Appl. No. : **09/988,728**
Filed : **November 16, 2001**

REMARKS

Discussion of Drawing Changes

FIG. 1A

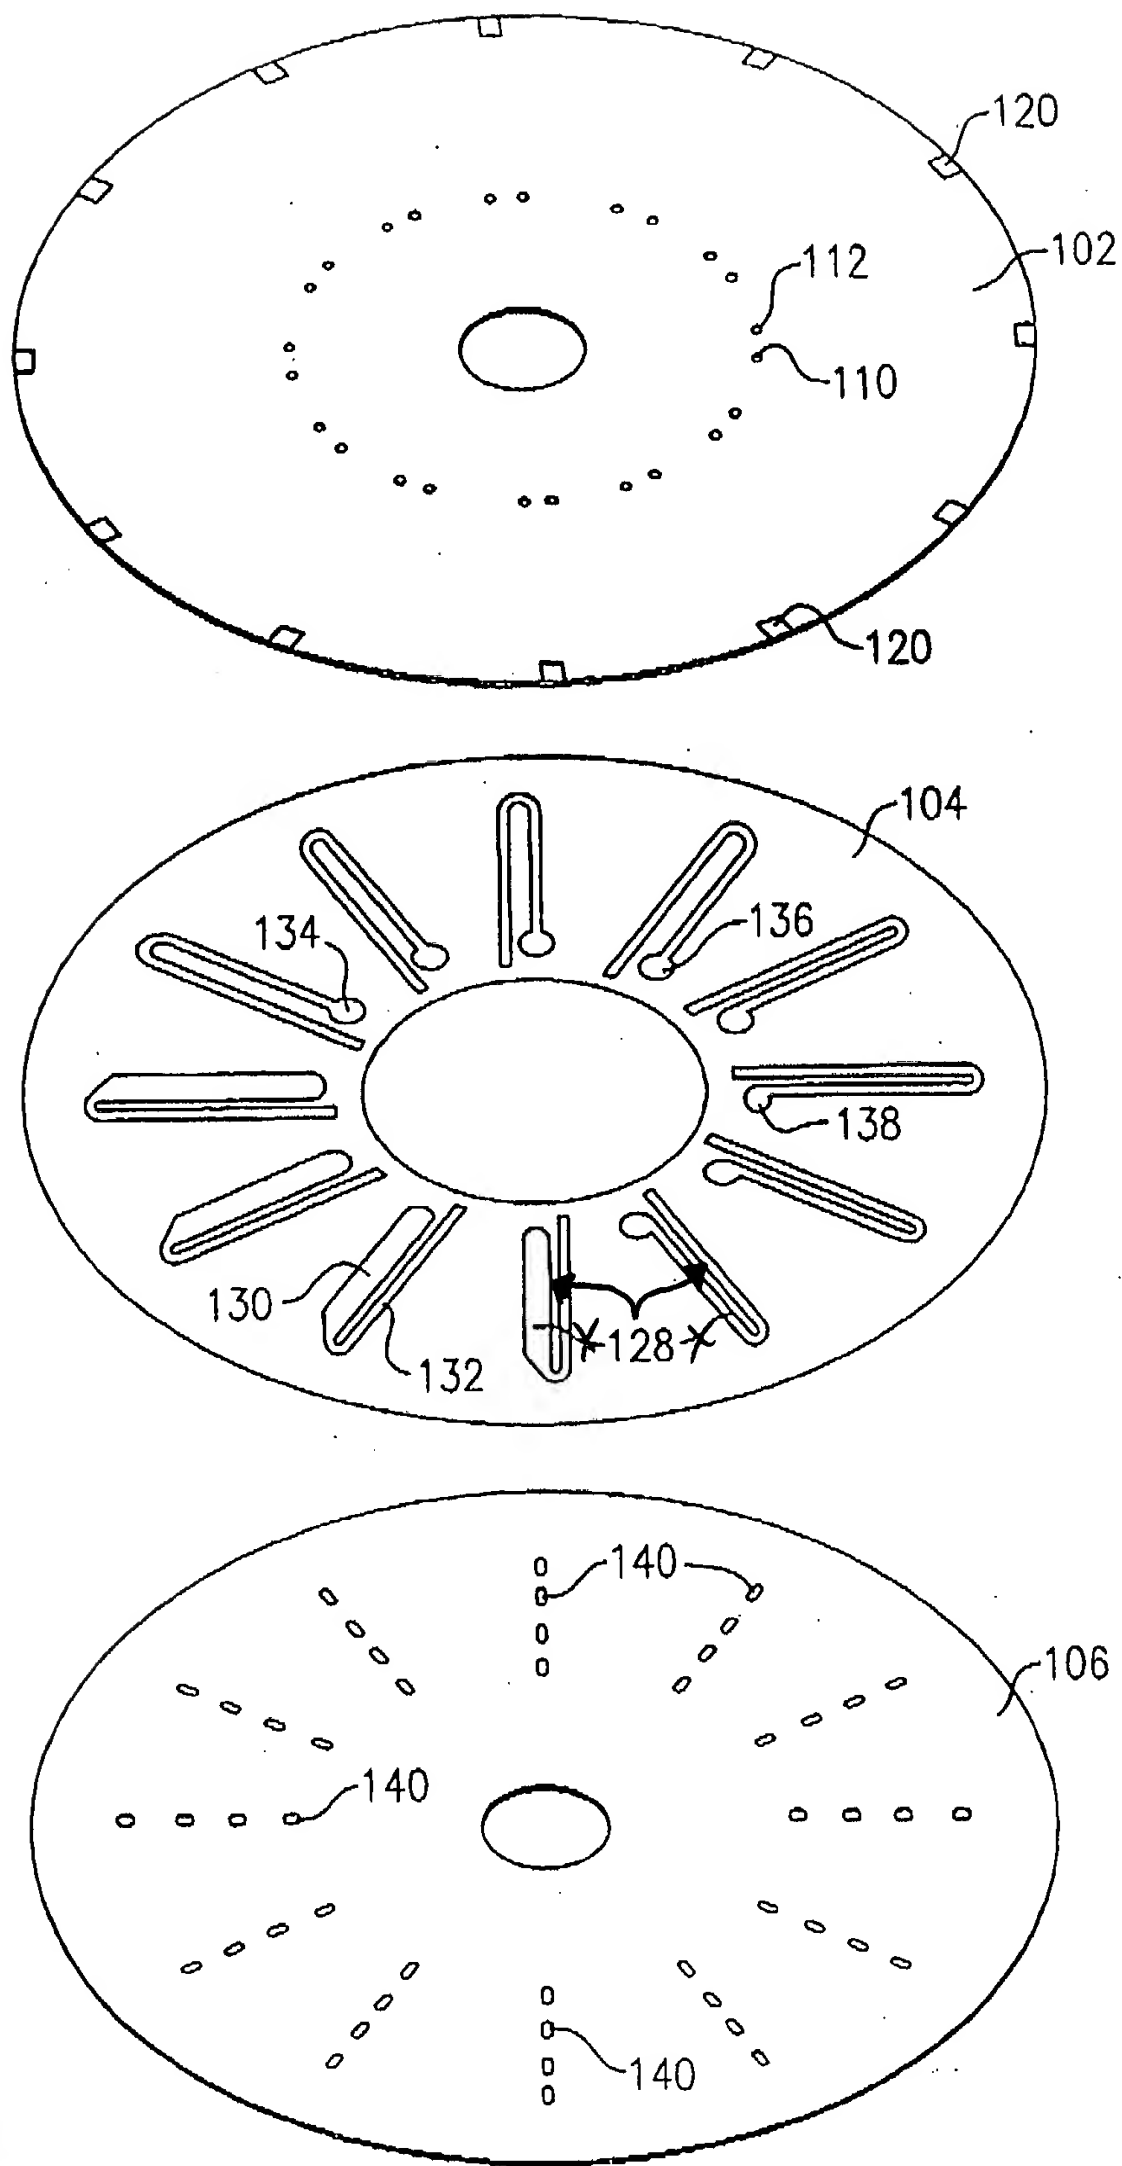
In the Office Action, the Examiner objected to the drawings for certain informalities. First, the Examiner stated that the reference sign 128 points to two different channel types. The Examiner suggested that the lines protruding from the number 128 be amended to not touch the channels. Applicant respectfully submits that he has amended Figure 1A in conformance with this suggestion. Furthermore, the Examiner stated that reference signs 134 and 136 are duplicates since the specification defines both as mixing chambers. Applicant respectfully notes that these reference numerals refer to different mixing chambers, and therefore requests withdrawal of this objection.

FIG. 1B

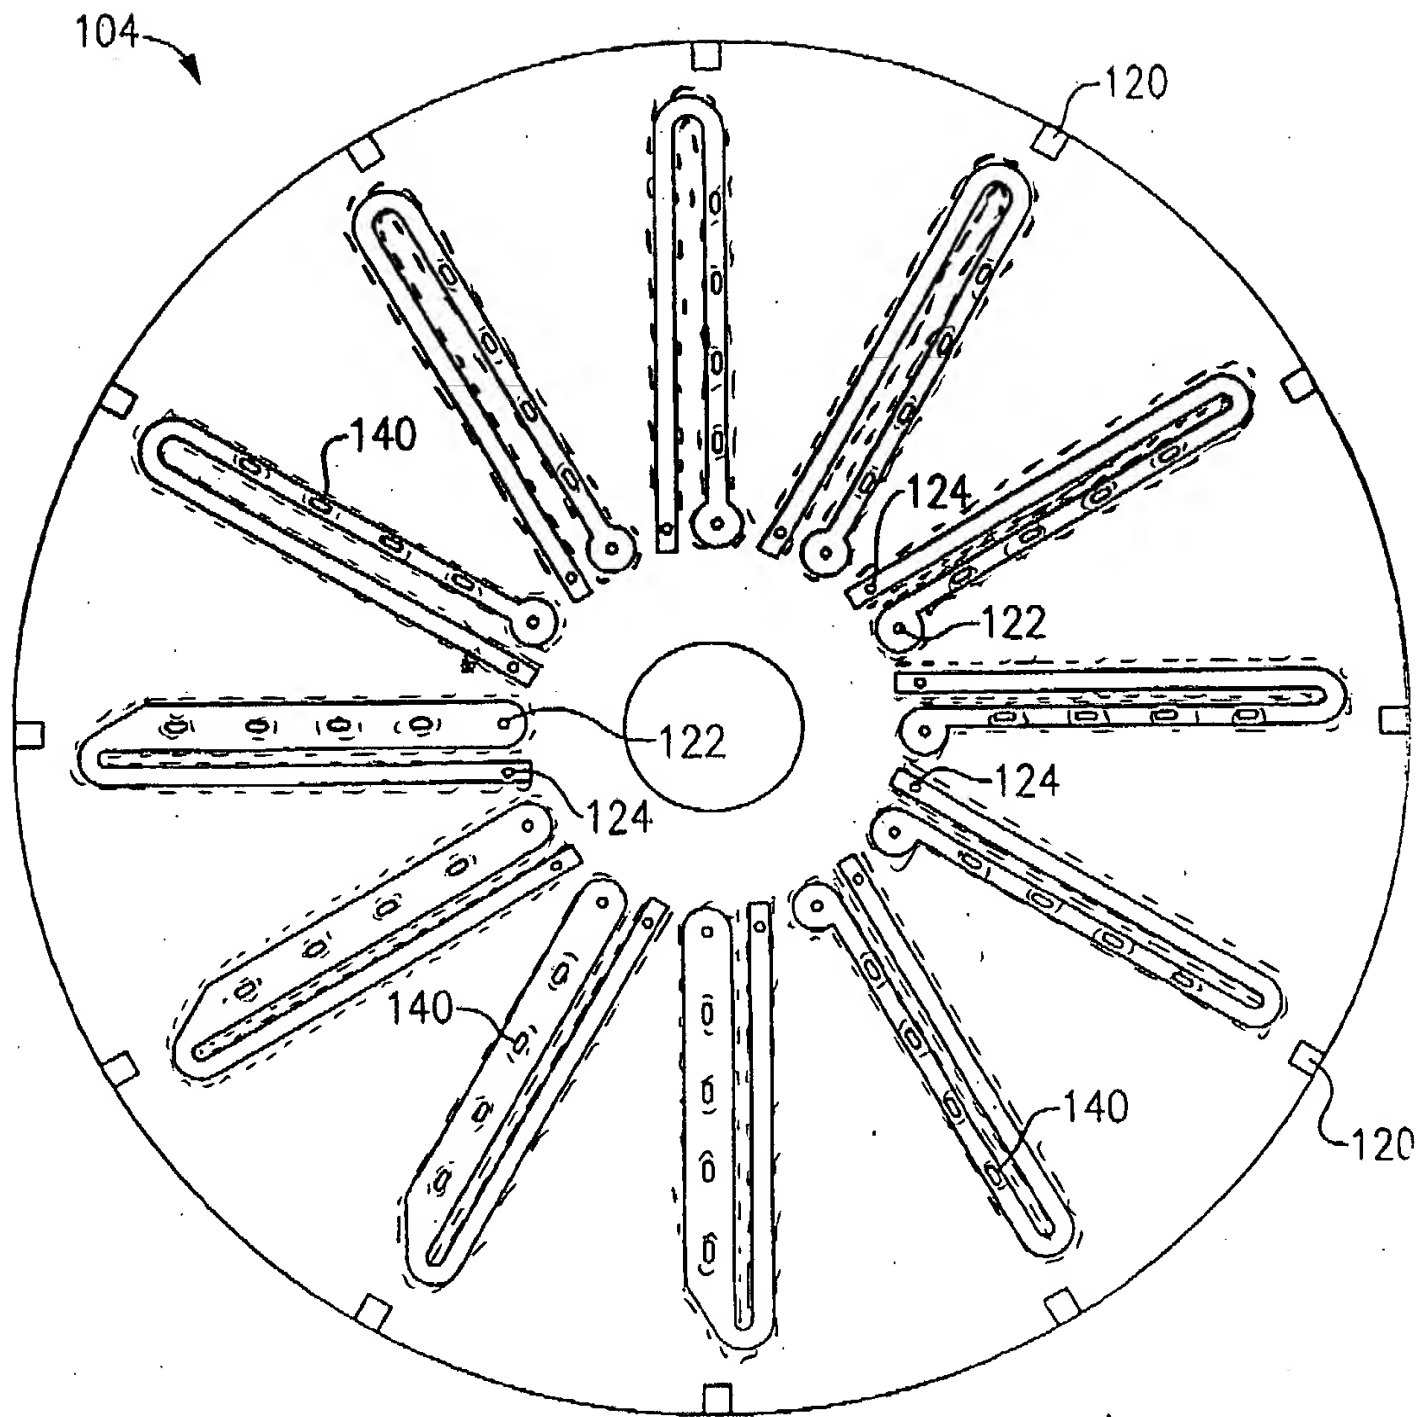
With respect to Figure 1B, the Examiner stated that reference sign 140 indicates "target zones" on substrate 106, which is not shown in the figure. Applicant notes that the target zones 140 are clearly shown on substrate 106 in Figure 1C. Applicant has corrected Figure 1B to dash out portions that would not be visible from a top-down view. With respect to Figure 1C, the Examiner indicated that chambers 164 should not be visible. Applicant has corrected Figure 1C to show these features in broken lines.

FIG. 1C

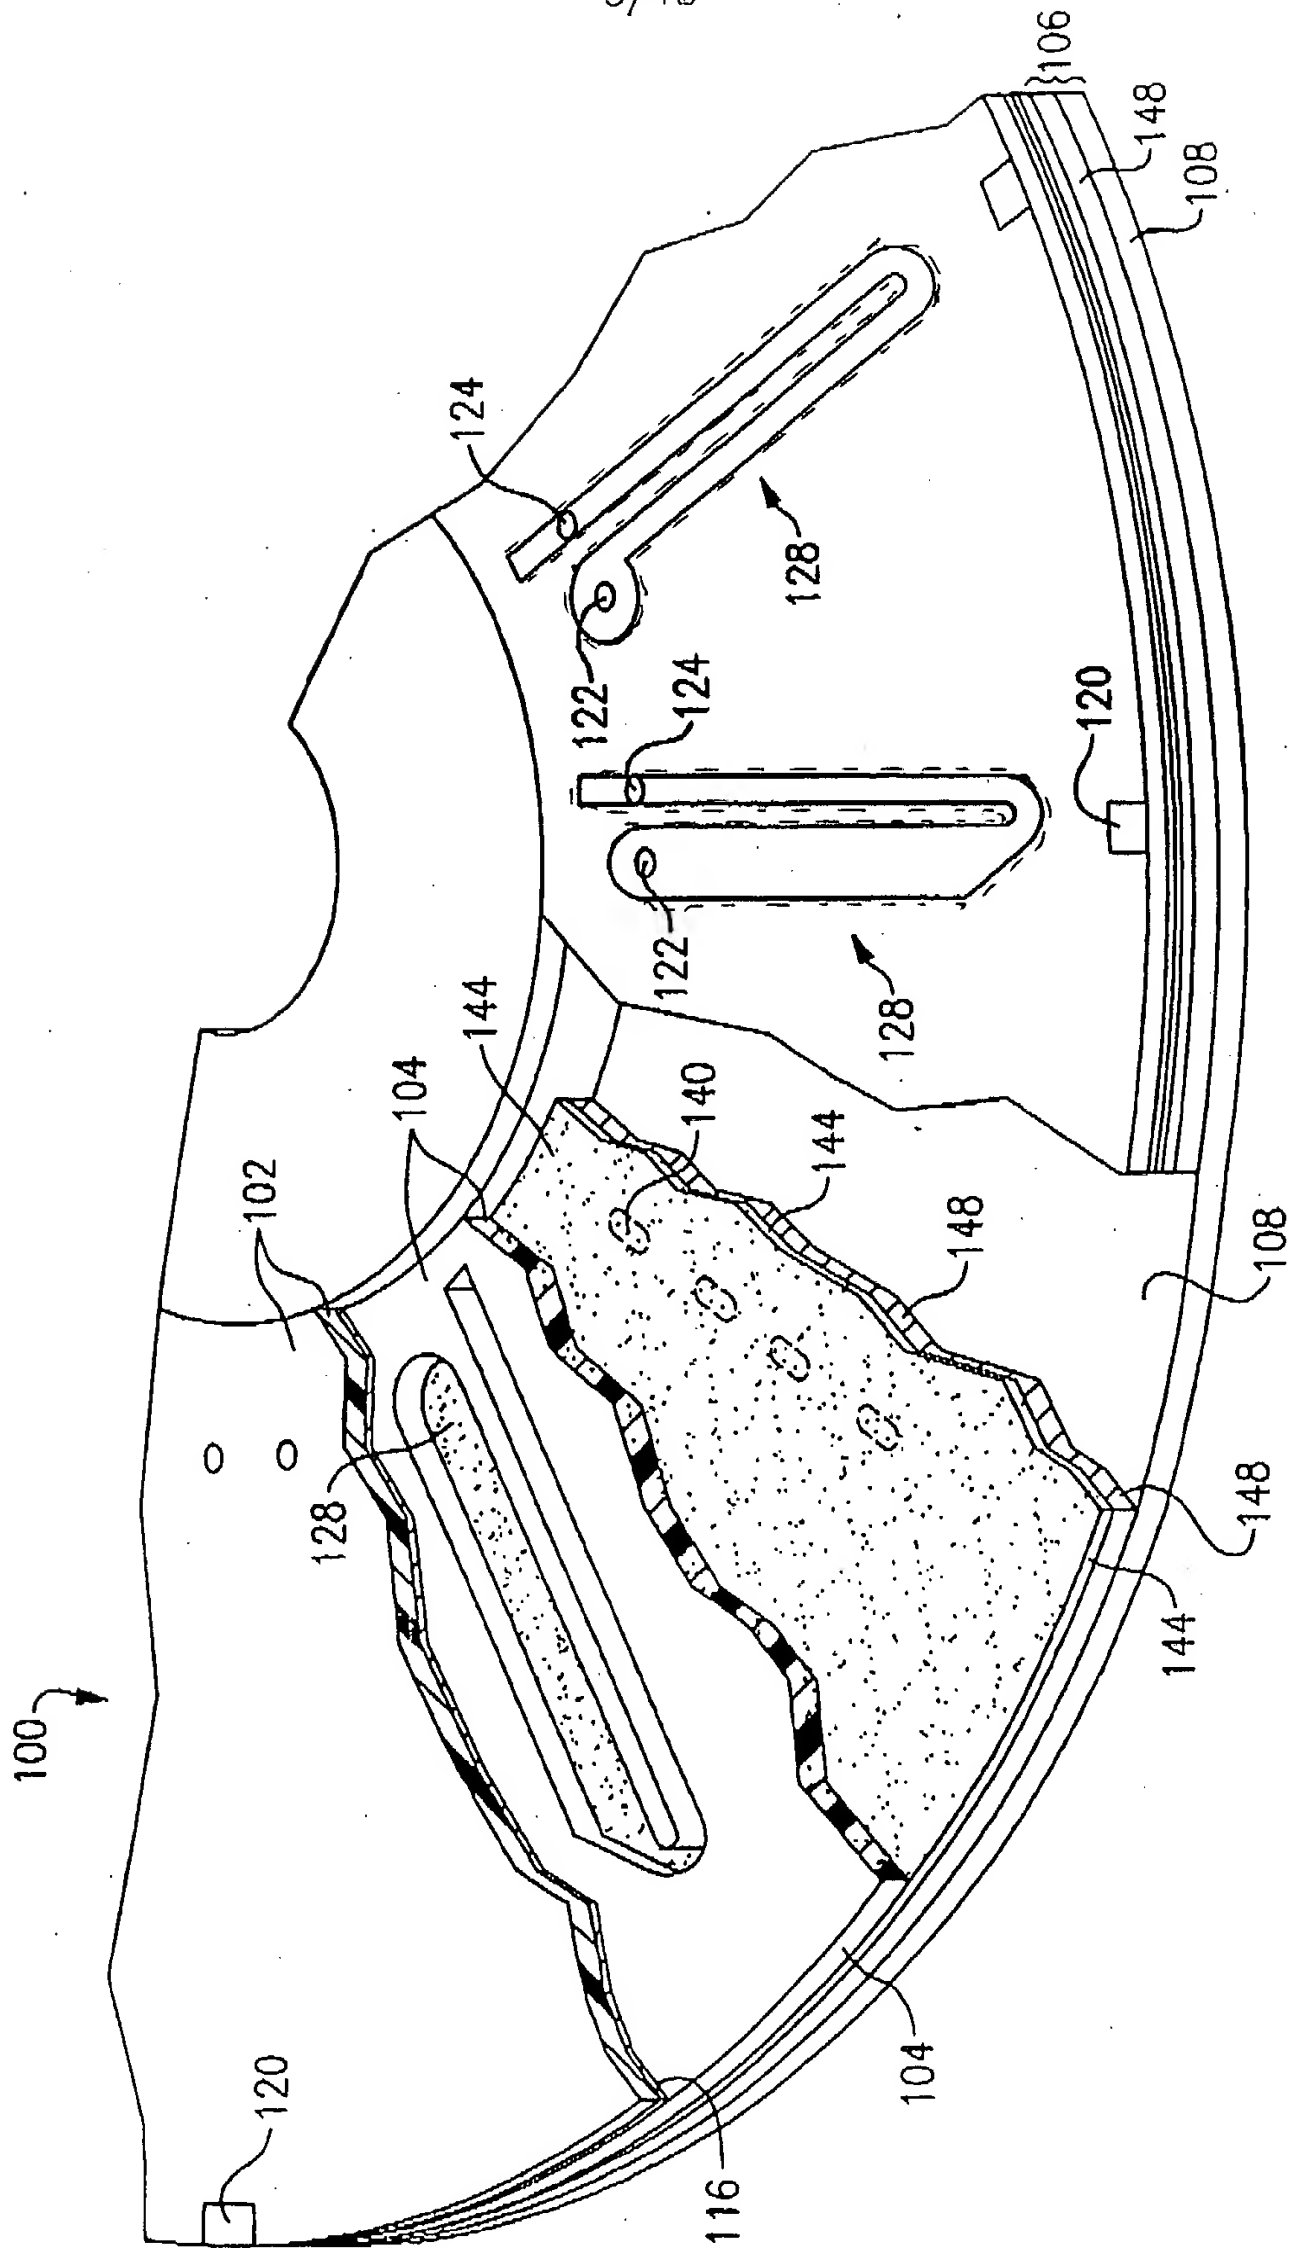
With respect to Figure 1C, the Examiner stated that the chambers 128 should not be visible on the right hand portion of the Figure. Applicant has amended the figure to correct this.

FIG. 2A

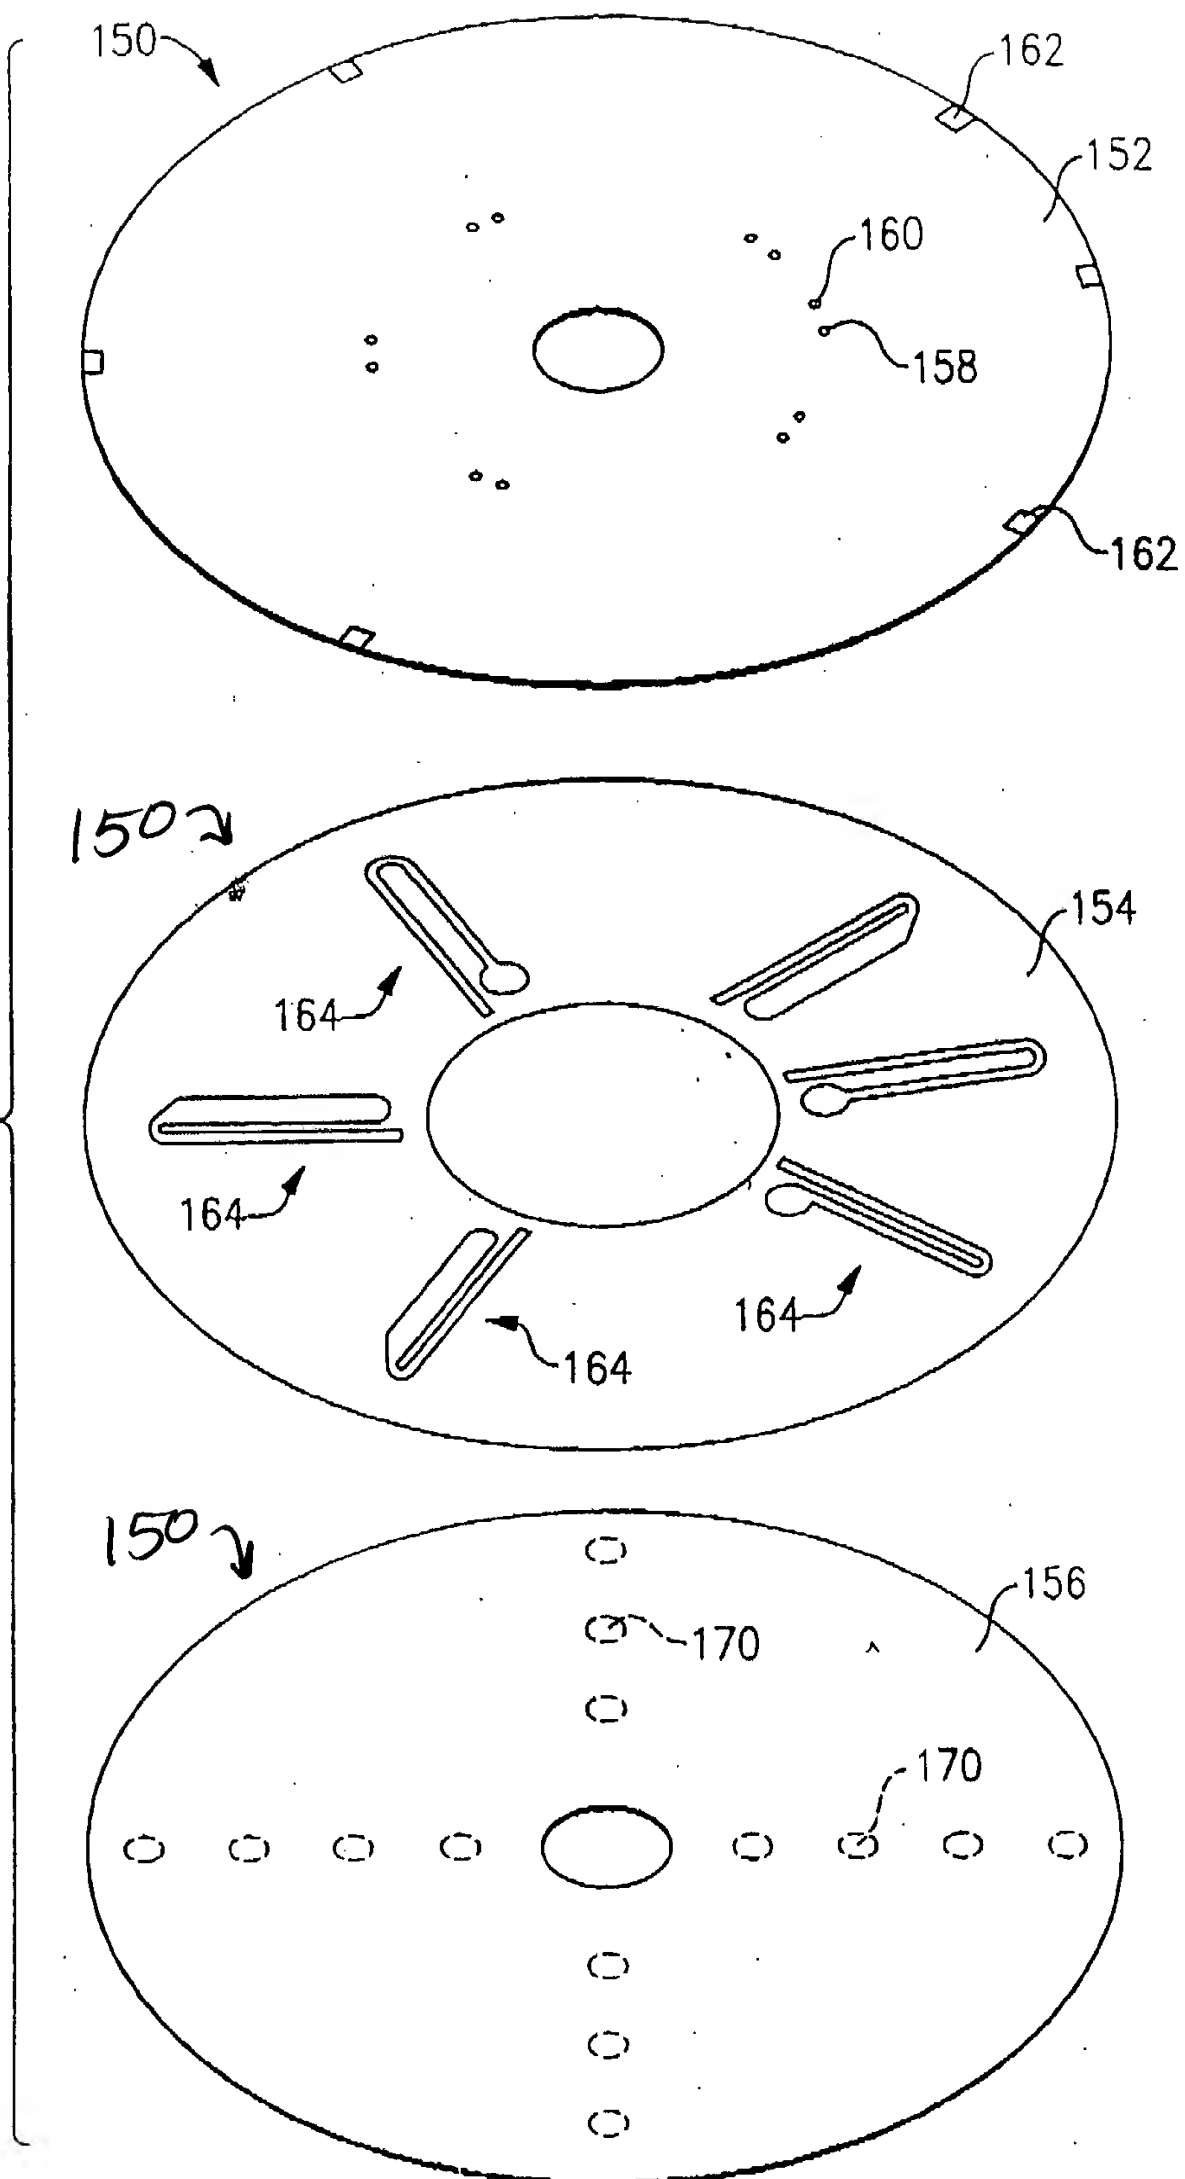
With respect to Figure 2A, the Examiner indicated that the positioning of reference sign 150 is misleading. Applicant has corrected this by the present amendments.
